Spotted inconsistencies between BIM Model 07/04/2022 and reality on-site

30/08/2022

US57 – North side Mezzanine

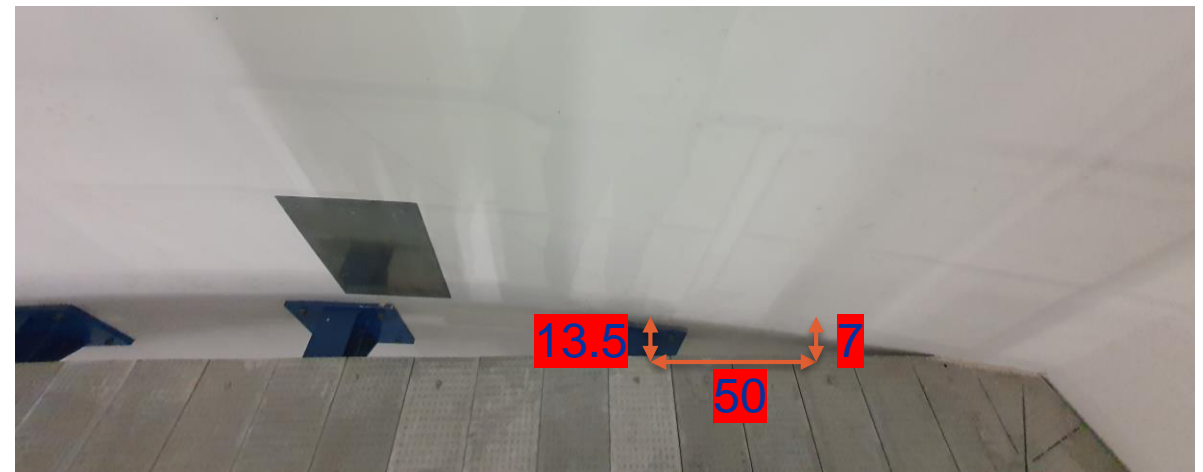
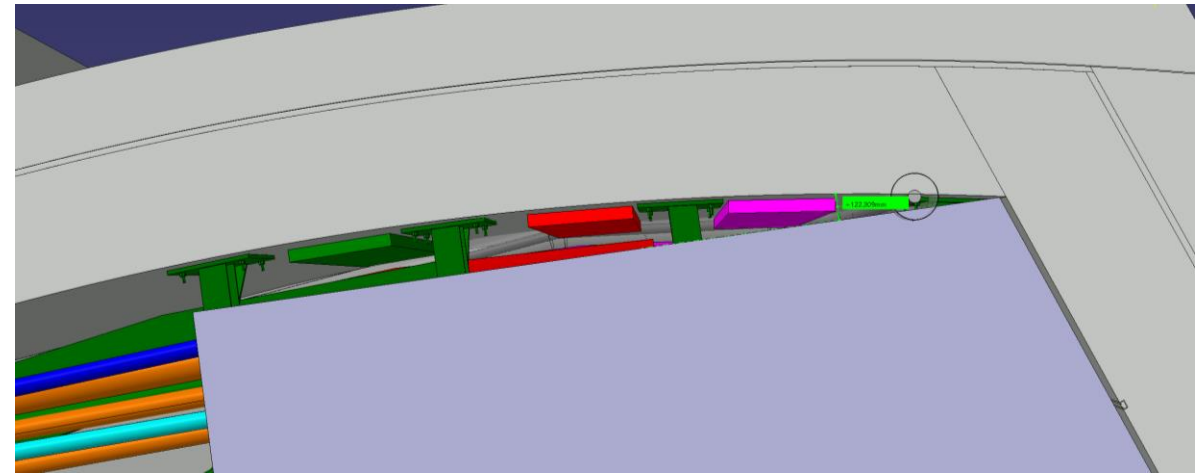
On the model :

- Free space between the vault from the right of the platine to the walkway : 16cm
- 50 cm further (thickness of the cable tray) : 12cm

On-site :

- 13.5cm
- 7cm

US57 – South side mezzanine

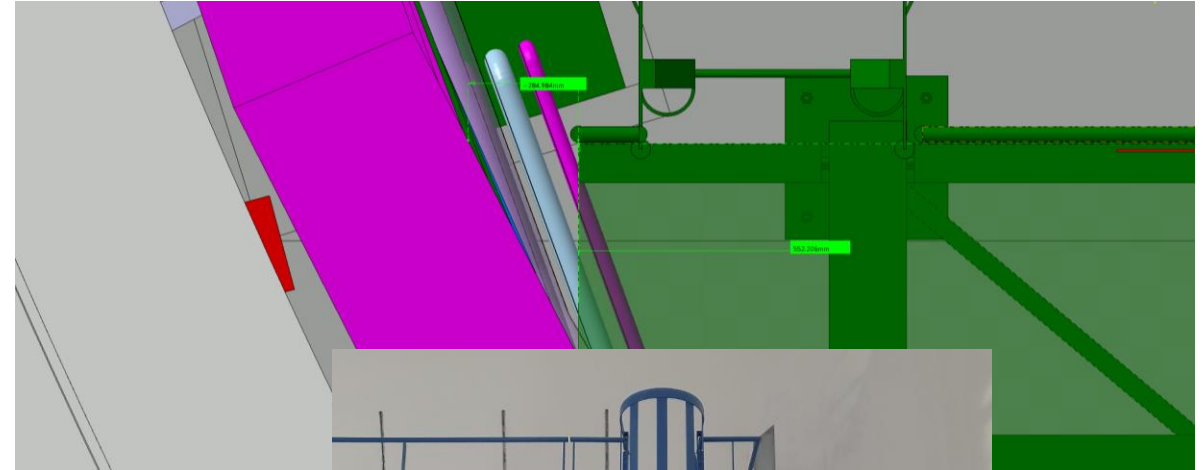
On the model :

- Length of the handrail :

On-site :

- Length of the L handrail : 95cm x 54cm
- Distance between the crinoline and the vault : 138cm

Solution proposed

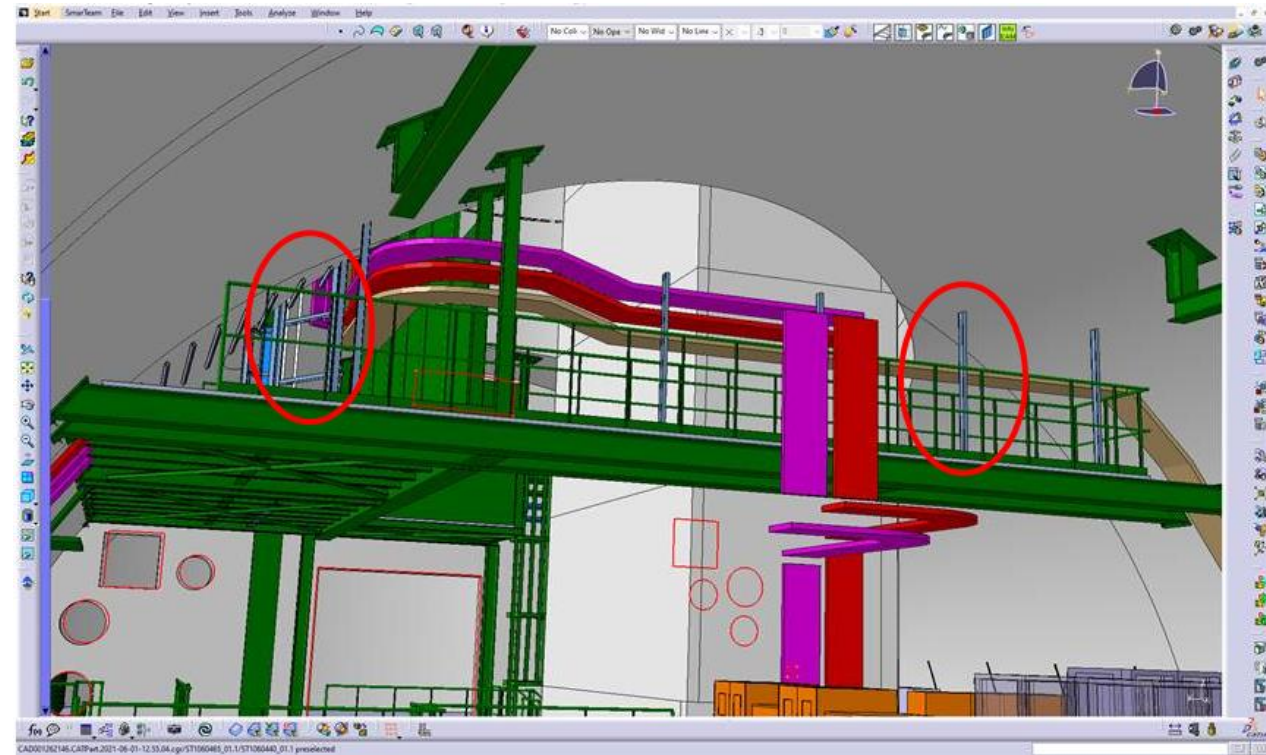
Distance between the platine and HEB100: 16.5 cm

Moving/modifying metal plates from the walkway to save space

Possibility of cutting the metal plates to **gain at least 3cm** of free space

Metallic support for cable trays

Would be installed after December 2022 **by others**
